**STAFF REPORT:** 9/14/2022 MEETING

**APPLICATION NUMBER:** #22-8009

**ADDRESS:** 269 WATSON

**SCOPE:** REPLACE EXTERIOR WALL AND DOORS (WORK STARTED WITHOUT APPROVAL),  
INSTALL REAR DECKS, ENCLOSED BASEMENT STAIRWELL AND BALCONY

*Elevations 1&2, by applicant: (North) rear of building showing proposed stairwell, decks, and balcony*

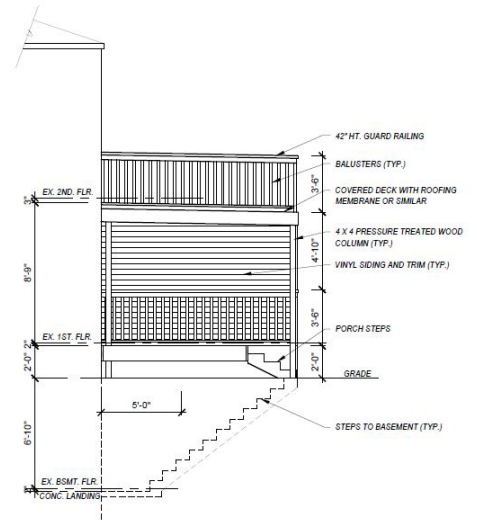
- Staff observed that the siding for the enclosed stairwell is vinyl and has asked the applicant if they would consider an alternative material. It is staff's opinion that the proposed vinyl siding is not an appropriate material consistent with the design and material of the house, as shown in the drawings. Staff requested confirmation on the use of this (or alternative material) with a product description sheets and a proposed color. At the time of this report, staff has not received a response.

- Other than the vinyl siding and lack of stain or paint for the decks/balcony, staff offers the opinion that the design, scale and materiality of the decks, basement stair enclosure and the balcony are appropriate.

- Staff recommends that the proposed rear basement access, rear decks and balcony are an appropriate design that does not conflict with the design of the house and is appropriate for the district. However, staff does recommend that the siding be of wood or cementitious board in a color and dimension that closely matches the house, with a smooth surface, and a color paint be selected per the HDC color guidelines.

NORTH ELEVATION @ 1/4" = 1'-0"

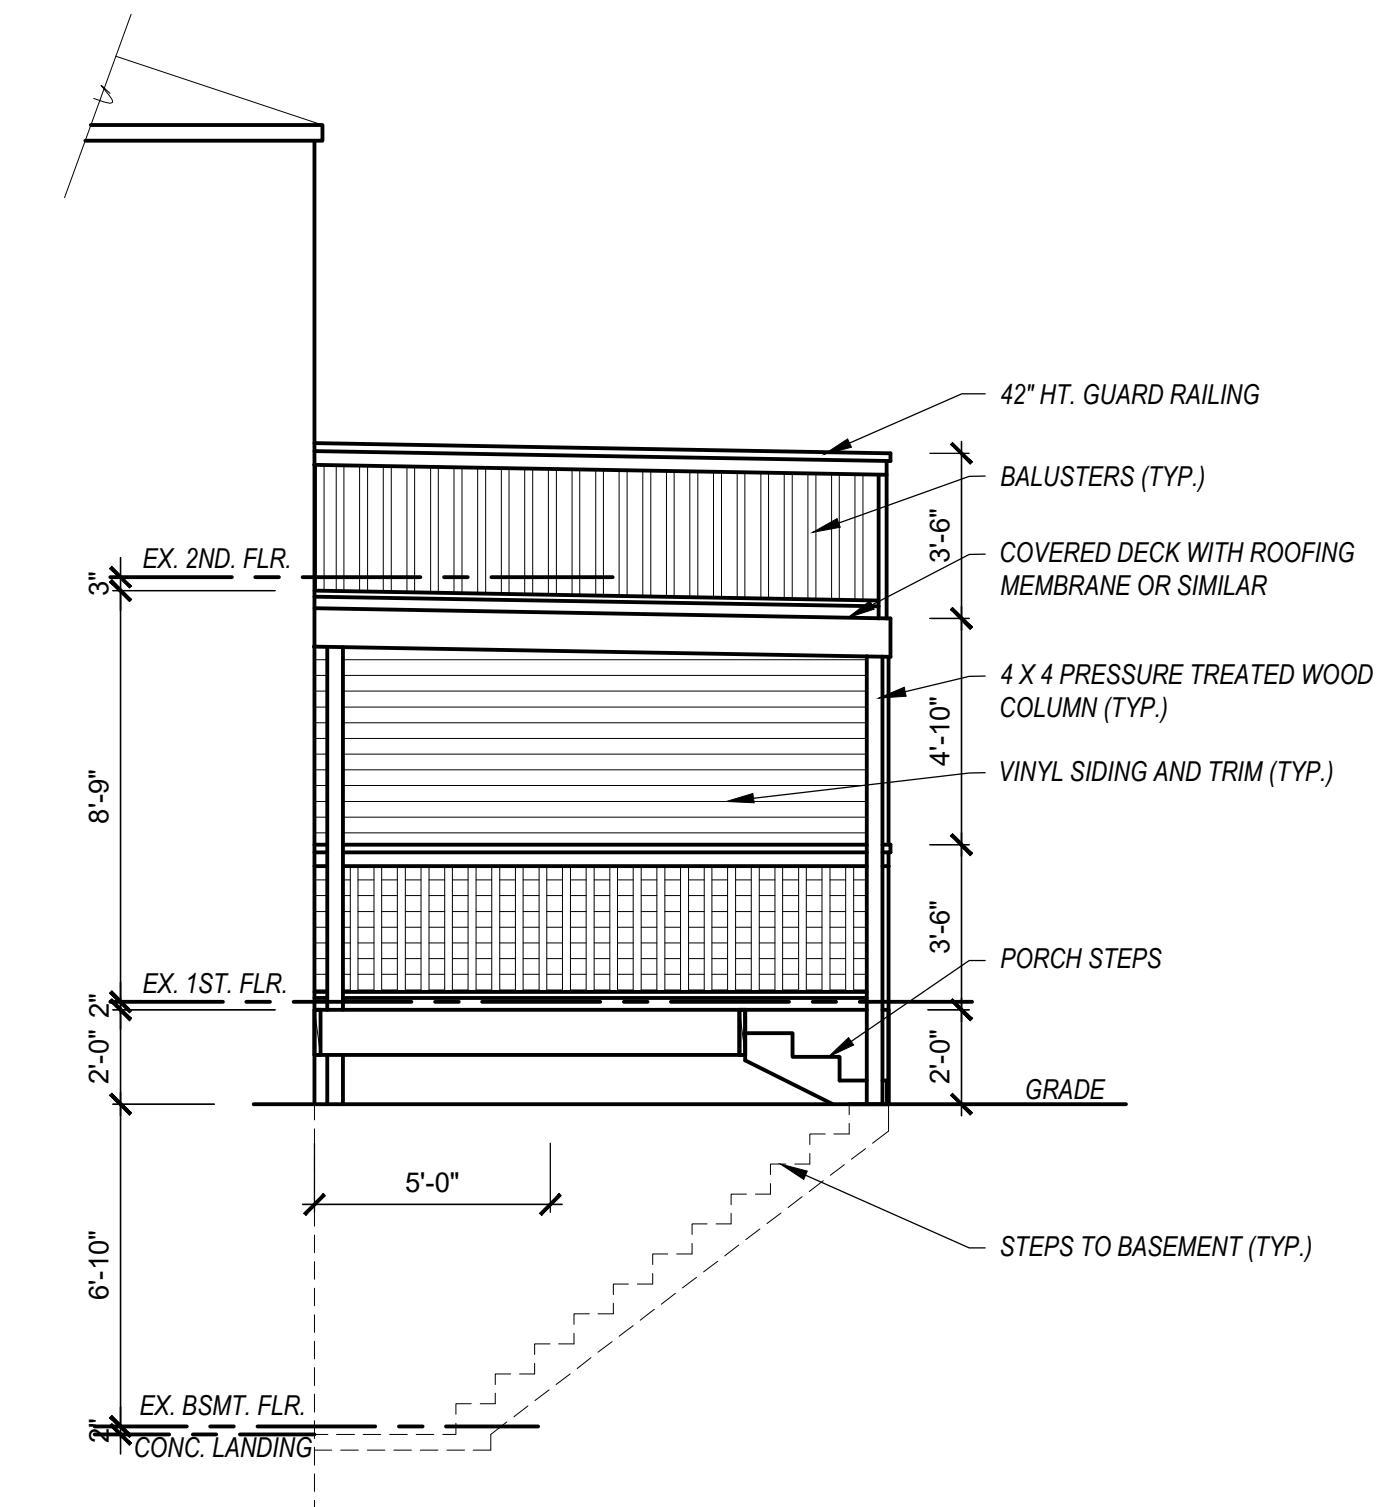
- Staff offers the opinion that because the rear elevation is not a primary or secondary elevation, and the removal of some brick material to access the basement is very minimal (approximately 2'x3' area) off the ground plane, the introduction of a new basement door for egress is appropriate.
